**Airways New Zealand Petition
to
The Director of Civil Aviation
to
amend the Whenuapai CTR/D
and
nearby GAAs**

15 December 2018

Airways submit a petition to amend the Whenuapai Control Zone (WP CTR/D NZA155), NZG151 North Shore and NZG154 Whenuapai as detailed and supported by this document.

Diagram 2 Requested WP CTR near North Shore aerodrome (NZNE).

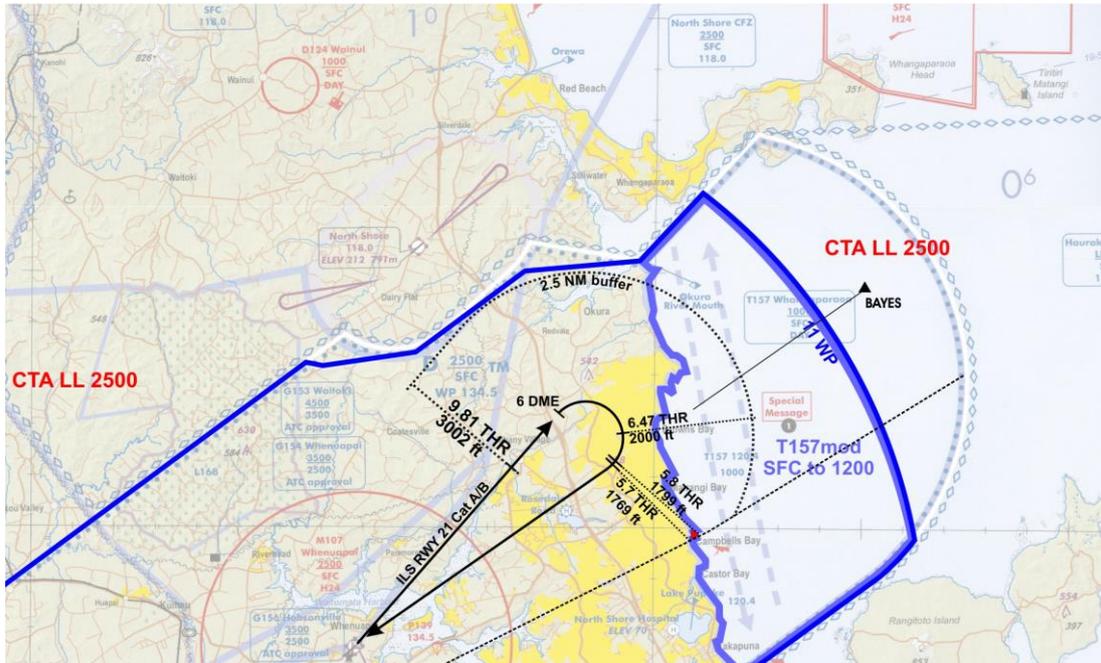
During consultation, the North Shore aerodrome (NZNE) operator requested less WP CTR to the north east near NZNE as the existing CTR boundary is very close (in to 1.5 NM) to the aerodrome making it difficult for VFR operations at NZNE to remain outside the CTR. CTR infringements are very possible and may have occurred.

The NZNE operator has indicated that that CTR boundary is fantastic and will be of real tangible benefit.

To address as much as possible the North Shore operator’s request, we request the WP CTR be reduced near NZNE as depicted in Diagram 2.

Diagram 9 Cat D circling area..

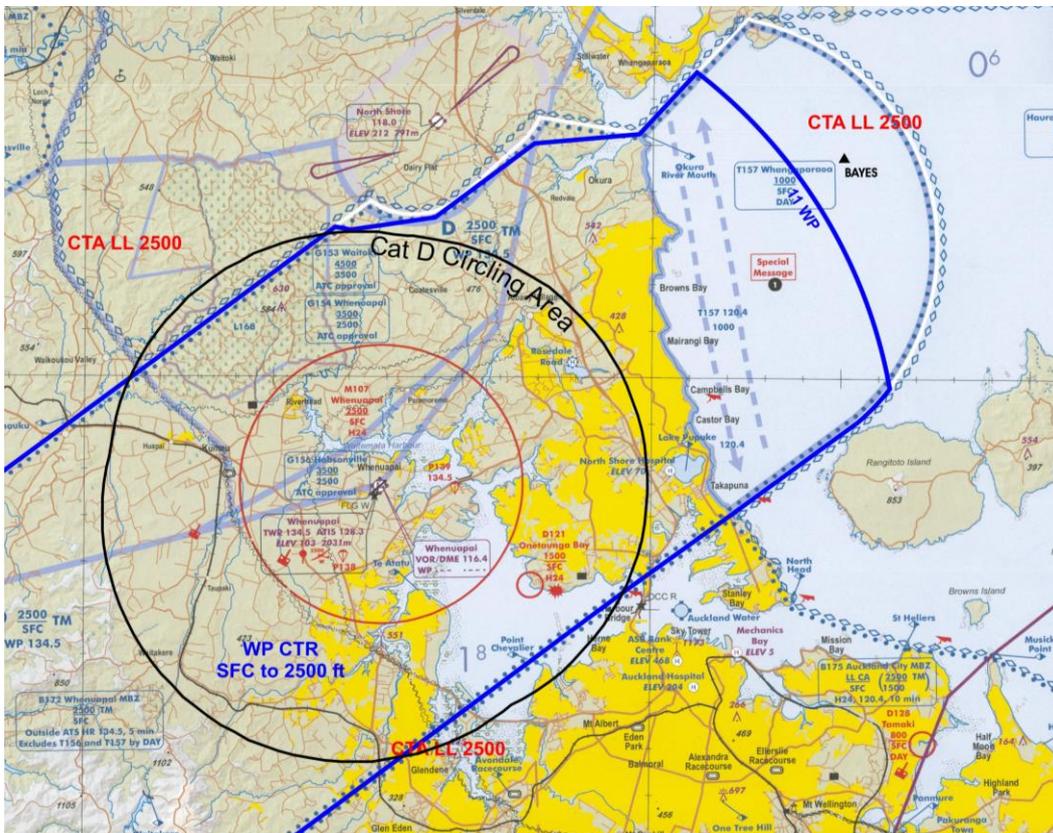
Diagram 9 below depicts the Cat D circling area, 5.28 NM radius centred on the RWY thresholds. As can be seen, this circling area is not fully contained by the existing CTR or the requested CTR.

The Airways understanding is that it would be rare for a Cat D aircraft to fly a circling approach at NZWP so it seems unjustifiable to us to widen the CTR to contain a rare Cat D circling approach.

If full containment of Cat D circling approaches is required then the CTR would need to be widened north and south by around 0.6 NM.

Our request is that the CTR 'width' is left as it currently is in this area. That results in the containment of Cat D circling remaining as it currently is – mostly, but not fully contained. If this request is accepted, the approach charts would be amended to include a statement such as "CAT D circling airspace containment not assured".

Diagram 10 Depicting areas of additional airspace needed for full containment of the RWY 08 and 26 approaches.

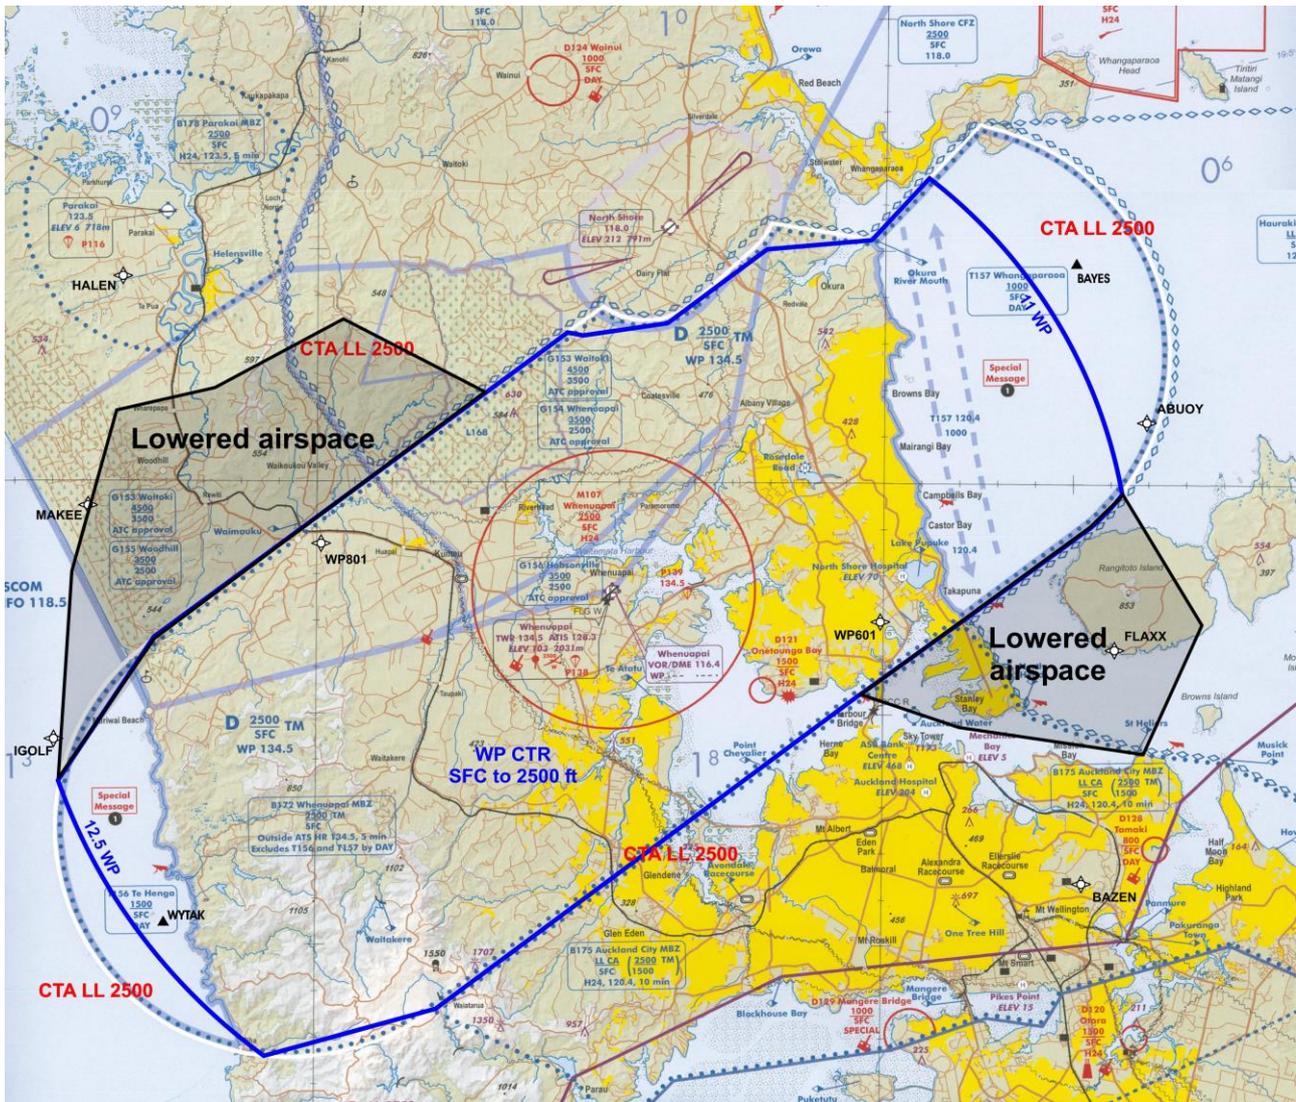
The Airways understanding from feedback from GA operators is that they would be very strongly opposed to any expansion of low level airspace in those areas. The Auckland Airspace Users Group (AAUG) feedback included;

The impact of lowering the airspace in the vicinity of Rangitoto Island/North Head to fully contain the RWY 26 approach would be significant. The currently uncontrolled airspace in this vicinity is regularly used by general aviation aircraft. Activities include helicopter and seaplane operations from the adjacent heliports and water aerodrome, aircraft overflying Auckland City, and also aircraft transiting the Auckland area. The area immediately seaward of a line joining Musick Point, North Head, and Okura River Mouth is the main north-south thoroughfare for general aviation aircraft. Most pilots try to avoid straying too far from land, it is already constrained inland by the built up area and corresponding minimum height limits, so vertical separation is the primary tool used to minimise collision risk. Lowering the airspace will compress activities into an even smaller volume of airspace.

Lowering the airspace in the vicinity of Waimauku to fully contain the RWY 08 approach would, for similar reasons to those stated at Point 6 above, have detrimental implications for general aviation aircraft. Whilst this area doesn't experience the same volume of traffic as Rangitoto Island/North Head it is regularly used by pilots from North Shore and Parakai Aerodromes and aircraft that use the west coast as an alternate north-south thoroughfare.

The Airways understanding is that the RWY 08 and 26 approaches are seldom used (around 5% of approaches) - mainly for training and occasional operational use in strong westerlies.

Having considered all the above, the Airways request is for the WP CTR to be as shown in Diagram 1, without extended airspace to fully contain the RWY 08 and 26 approaches (i.e. those approaches not fully contained) with;

- the WP RNAV RWY 08 and 26 approaches being amended to raise the minimum procedure commencement altitudes to 3000 ft.; and
- the approaches annotated on AIPNZ approach charts as “Airspace containment not assured (further details)” or other similar wording. This process to include exploring the possibility of the annotations including the distances on final at which the approach is not contained.

Diagram 11 The geometry of the ILS/DME RWY 21 teardrop approach indicating that the transit lane upper limit could be up to 1200 ft, at least 500 ft below the profile of the approach.

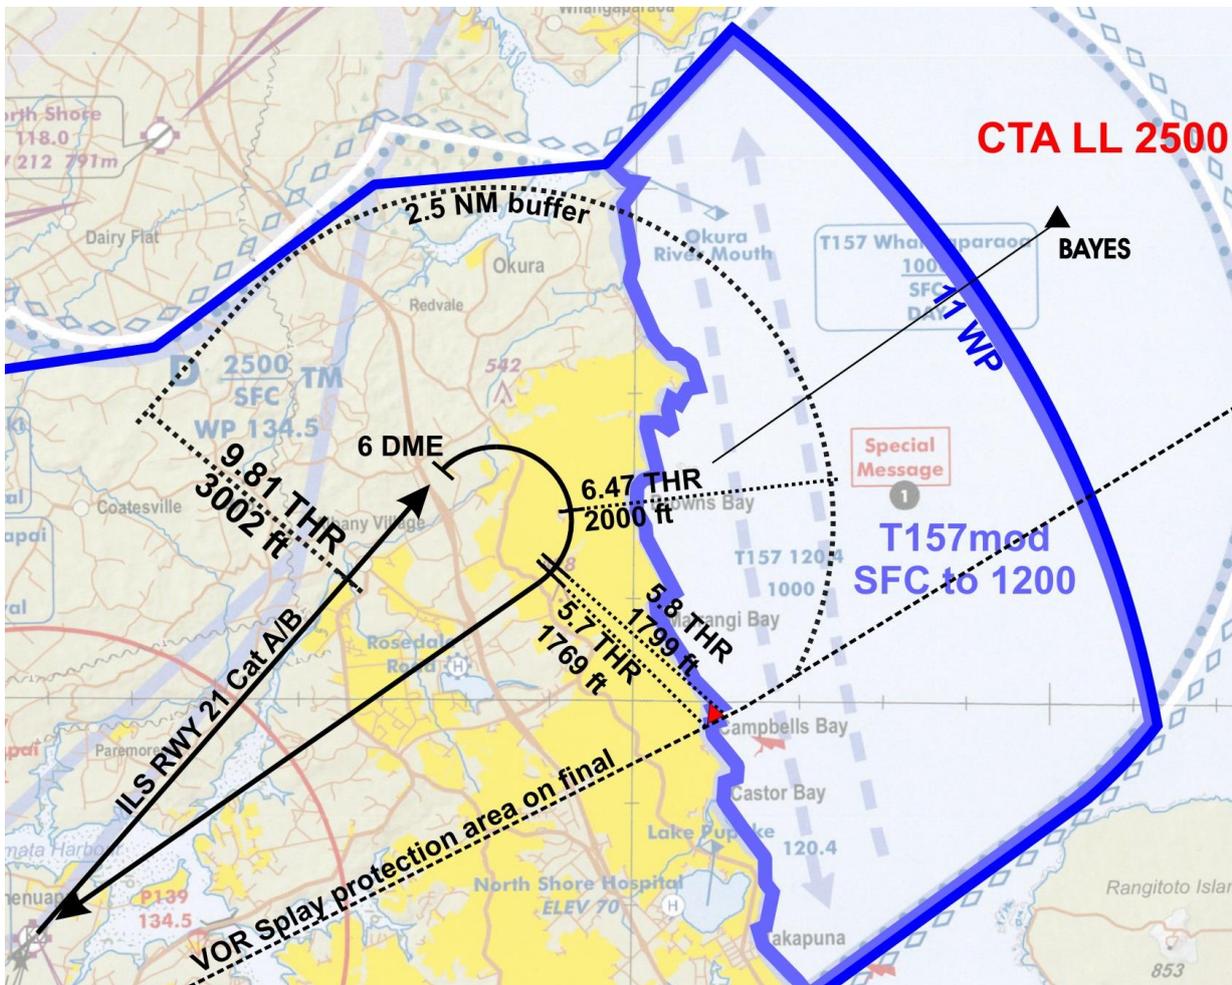
The RNZAF feedback is that they are opposed to a proposal for the transit lane to be raised above 1000 ft – their feedback copied below.

The proposal again assumes aircraft will fly the published 2.9° or 3.0° glide paths. If the upper limit of T157 was increased above 1000ft then an aircraft flying the RWY 21 VOR/DME Cat C/D procedure via a step down approach could fly perpendicularly through the transit lane and increase the potential for conflict. This could also occur in the VOR/DME Cat A/B approach, though less likely due to the probable aircraft flight path and performance, but is a consideration for any LOC/DME approach too.

In addition, operators of Cat D aircraft advised such a change would introduce potential conflict should extended upwind RWY 03 or downwind RWY 21 circuits be required given their circuit altitude of 1500 ft.

Finally, the CTR immediately above T157 is often utilised to facilitate military training, especially airdrop of both equipment and personnel. Increasing the upper limit of T157 would significantly raise the potential for conflict during what is a high workload period for military flight crews and is therefore extremely undesirable.

The constraints that determine the eastern transit lane height are noted, and the proposed increase to 1200 feet is supported. Whilst it is only a 200 foot increase over present day, any increase in the airspace available to assist with see-and-be-seen separation is positive.

Therefore, we have based our transit lane request solely on the airspace design policy of applying a 300 ft per NM gradient for departures and approaches – this being in-line with AIPNZ ENR 1.5 – 2 paras 1.3.2 and 1.3.3. That policy allows for the upper limit to be 1200 ft so this is what we are requesting. We highlight to CAA the RNZAF's opposition to raising the upper limit above 1000 ft and anticipate that the RNZAF will reiterate their position during consultation carried out by CAA.

Airways agrees to the lower 1000 ft upper limit for the transit lane if this is what results from the CAA deliberations.

Diagram 12. Depicting T156mod and the containment requirements for the Cat A and B teardrop to ILS RWY 03.

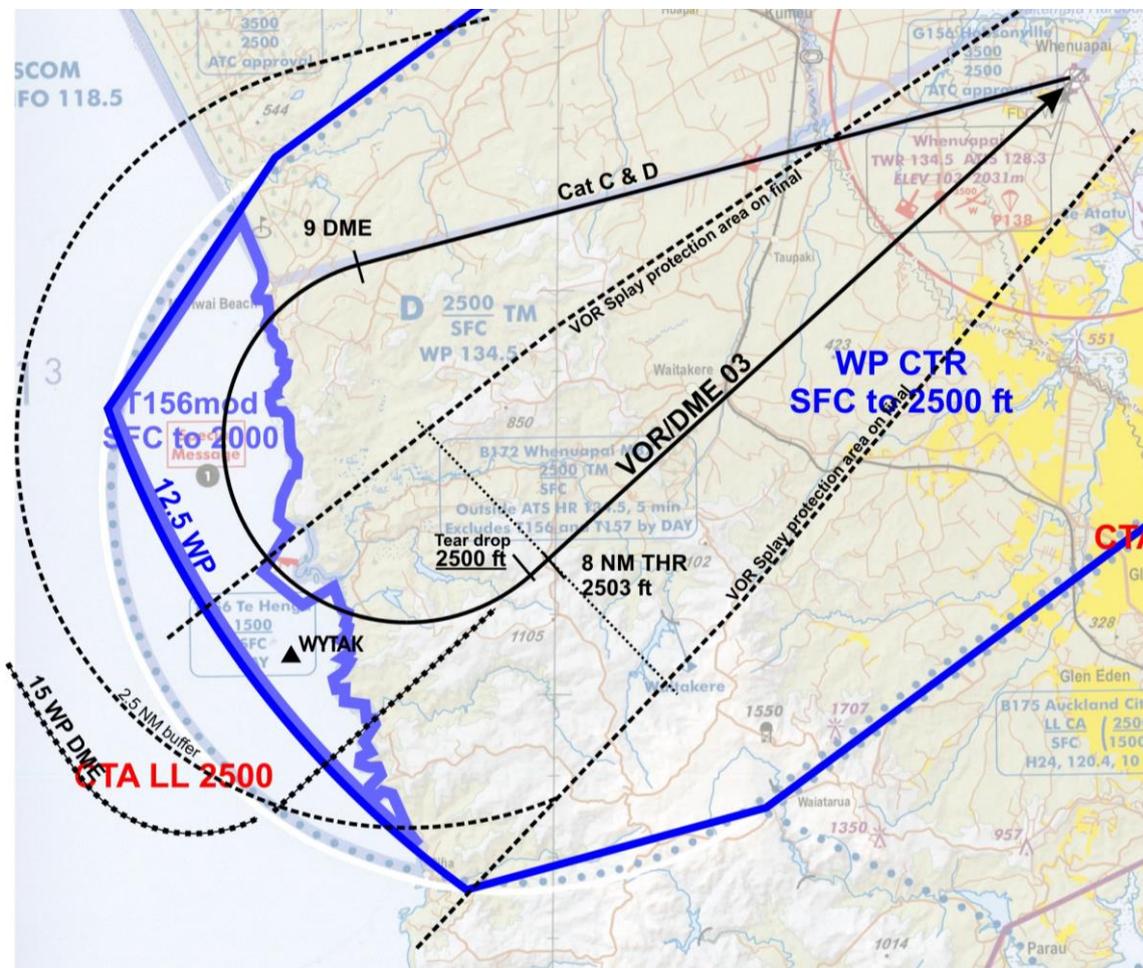
Increase in upper altitude limit of T156 to 2000 ft.

The proposal assumes aircraft will fly the RWY 03 VOR/DME Cat A/B/C/D published 3.5° glide path. If the upper limit of T156 was increased then an aircraft flying the same procedure via a step down approach (this remains a military training requirement) could fly perpendicularly through the transit lane and increase the potential for conflict, this is also a consideration for any LOC/DME approach. **Opposed** as presented but acceptable if **Modified** to an upper limit of 1800ft.

Alternatively, NZWP approach plates could be **Modified** to increase the OCA step height to "not below 2000 feet", i.e. 2000.

The constraints that determine the western transit lane height are noted, and the proposed increase to 2000 feet is supported. This 500 foot increase coupled with the reduced 12.5nm lateral boundary provides greater flexibility for general aviation aircraft operating along the west coast.

Similar to the eastern transit lane, the Airways request for 2000 ft upper limit is based solely on the airspace design policy and highlights to CAA the varying feedback regarding the upper limit of the western transit lane. We anticipate that the CAA consultation process will result in the most appropriate upper limit being determined.

Airways agrees to the upper limit for T156 being any level 2000 ft or lower.

Diagram 13. Depicting possible T156mod slightly inland of the coast in the southern portion.

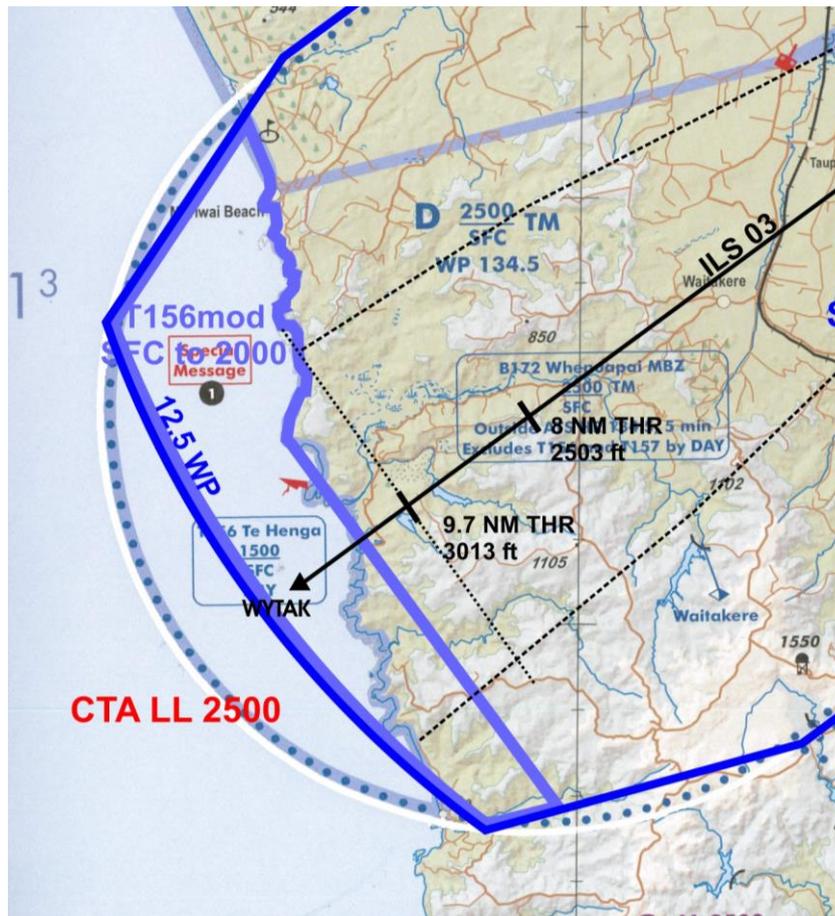
Changing the transit lane lateral dimensions introduces a source for potential positional error by transiting pilots, as opposed to 'seaward of the coast'. Units stated GA/VFR aircraft location would be more predictable based off prominent geographic reference and therefore 'seaward of the coast' remains preferential; also questioned was the practicality of placing the transit lane over predominantly high ground which is often not suitable for transit under VMC. The proposal is therefore **Opposed**.

With electronic charting and moving map displays becoming more prevalent in general aviation aircraft, situational awareness is achievable without needing prominent geographic boundary features. This being the case, the possible extension of the western transit lane inland from the coast is supported.

Having considered that feedback, Airways has elected to request the transit lane as shown on Diagram 12 without the portion inland of the coast. But we highlight to CAA this possibility and anticipate that the option may be raised during their consultation.

Airways agrees to the boundary being brought inland of the coast as per Diagram 13 if that is what their deliberations arrive at.

Diagram 14 Possible GAA boundary (black line) change with the proposed WP CTR.

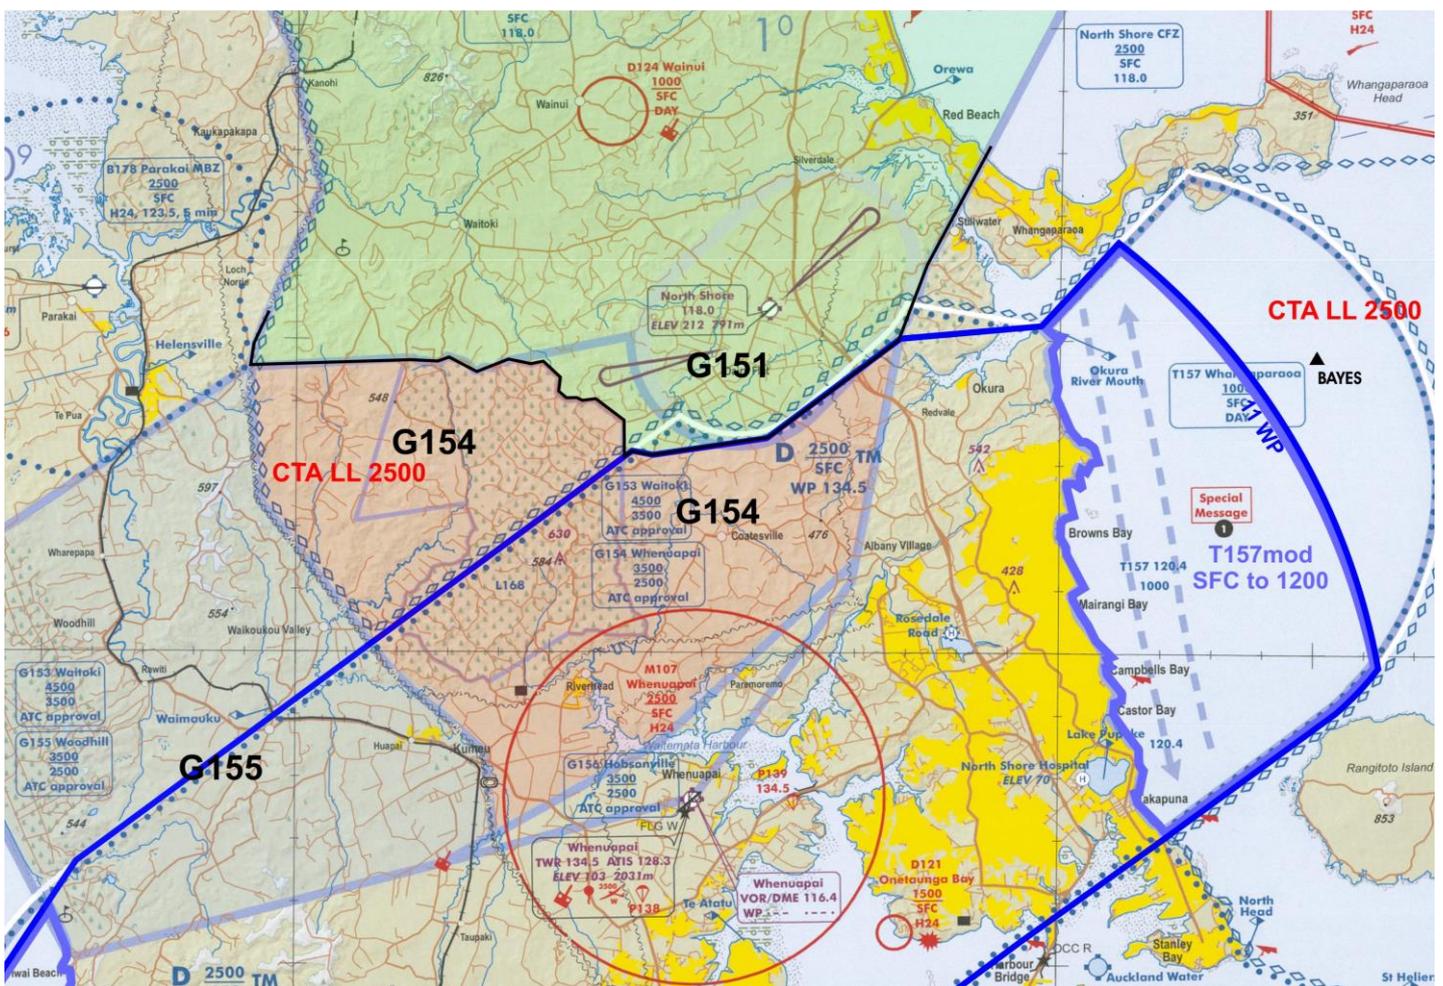
Also, in response to the suggestion from North Shore Aero Club (NSAC), the southern boundary of G151 and matching G154 boundary is requested to be modified to follow the edge of riverhead forest and associated Blackbridge Road. This boundary is the same as the boundary for L168 to where it meets the CTR boundary.

NSAC's feedback stated that the boundary like that would make training operations within the North Shore GAA G151 much easier from a navigational perspective, particularly when taking into account student pilots being the lowest common denominator.

One little possible issue with the boundary like that following the LFZ boundary is that it may be difficult to interpret from the overlapping boundary lines where the LFZ L168 boundary lies. Airways suggests that this possible issue is discussed during the CAA consultation.
